Agenda Item #: 2 - EXTENSION SUB-002158-2022

Preserve at Milkhouse Creek Subdivision

- One-year extension of Subdivision approval to create 49 legal lots of record from five (5) metes-and-bounds parcels.

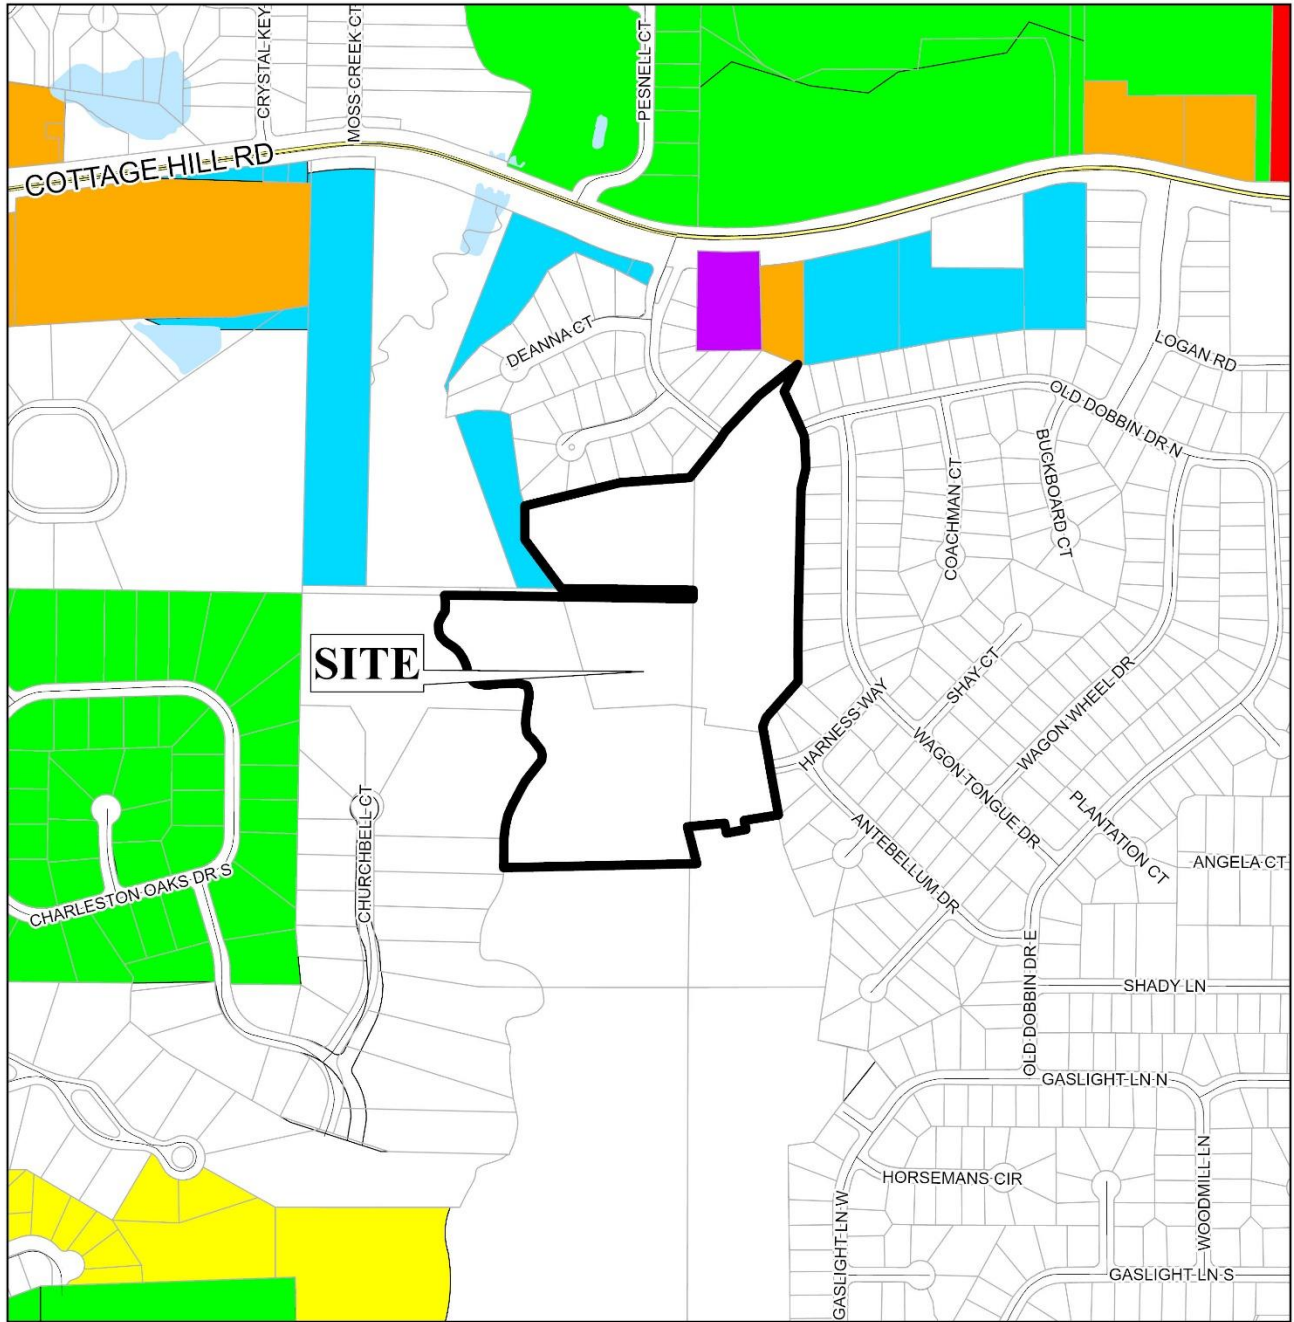
- 1) retention of the right-of-way width label for all streets on the Final Plat;
- 2) retention of the 25' minimum building setback line along all street frontages on the Final Plat;

- 3) retention of each lot with its size in both square feet and acres, or the furnishing of a table on the Final Plat providing the same information;
- 4) revision of Note #10 concerning structures in easements to state on the Final Plat that no structures shall be constructed or placed within any easement without permission of the easement holder;

- 5) revision of Note #14 concerning the maintenance of detention facilities, common areas and wetlands to state on the Final Plat that the maintenance of all Common Areas is the responsibility of the property owner(s);

- 6) compliance with the Engineering comments: *(A. Provide all of the required information on the SUBDIVISION PLAT (i.e., signature blocks, signatures, certification statements, written legal description, required notes, legend, scale, bearings and distances) that is required by the current Alabama State Board of Licensure for Professional Engineers and Land Surveyors. B. On Sheet 1 of 3 -correct the LOT numbers shown in the DRAWING INDEX. C. On Sheet 1 of 3 – show and label the existing ROW for Blue Ridge Blvd., Old Dobbin Dr. N., Old Dobbin Dr. W., and Harness Way. D. Sheet 2 of 3 - show and label the existing ROW for Blue Ridge Blvd. Old Dobbin Dr. N., and Wagon Tongue Dr. E. Sheet 2 of 3 – Provide the exact measurement “observed” on the property lines that begin/end in Milhouse Creek. The monumentation indicates that an exact measurement should be available. F. Sheet 2 of 3 – Label each and every Common Area. G. Sheet 3 of 3 – show and label the existing ROW for Old Dobbin Dr. W., and Harness Way. H. Sheet 3 of 3 – Show and label the BFE (Base Flood Elevation) on each lot (LOT 41, 42, & 43) that contains an AE, V, or X (shaded) flood zone designation. BFE for that portion is elevation 51’. I. Sheet 2 & 3 - Check and revise the distances shown on the Plat and in the legal description. Four (4) legs do not show the bearing, and one (1) does not show the distance. J. Sheet 2 & 3 - Check the monumentation and written bearing and distance for the part that includes the western property line along Milkhouse Creek. The distances shown and written should be exact distances since the distance is between sets of capped rods. K. Label the different Common Areas on each of the three (3) sheets. L. Revise the plat to label the size (acres and square feet) of each Common Area. Place it underneath the Common Area label. M. Provide a note that a 25' riparian buffer may be required, during development, along the edge of anything considered by ADEM to be a water of the state. N. All subdivision corners (exterior and interior) are*

required to be set prior to the City Engineer signing the PLAT. O. Email a pdf copy of the FINAL SUBDIVISION PLAT and LETTER OF DECISION to the Permitting Engineering Dept. for review at land.disturbance@cityofmobile.org prior to obtaining any signatures. No signatures are required on the drawing.);

- 7) *placement of a note on the Final Plat stating the Traffic Engineering comments: (A traffic impact study has been previously conducted for this site and no off-site improvements are warranted based on the findings in the study. Driveway number, size, location, and design to be approved by Traffic Engineering and conform to AASHTO standards.);*

- 8) *compliance with the Urban Forestry comments: (Property to be developed in compliance with state and local laws that pertain to tree preservation and protection on both city and private properties [Act 929 of the 1961 Regular Session of the Alabama Legislature (Acts 1961, p. 1487), as amended, and City Code Chapters 57 and 65]. Private removal of trees in the right-of-way will require approval of the Mobile Tree Commission. Removal of heritage trees from undeveloped residential sites, developed residential sites in historic districts, and all commercial sites will require a tree removal permit.); and*

- 9) *compliance with the Fire Department comments: (All projects within the City Limits of Mobile shall comply with the requirements of the City of Mobile Fire Code Ordinance (2012 International Fire Code). Fire apparatus access is required to be within 150' of all commercial and residential buildings. A fire hydrant is required to be within 400' of non-sprinkled commercial buildings and 600' of sprinkled commercial buildings.).*
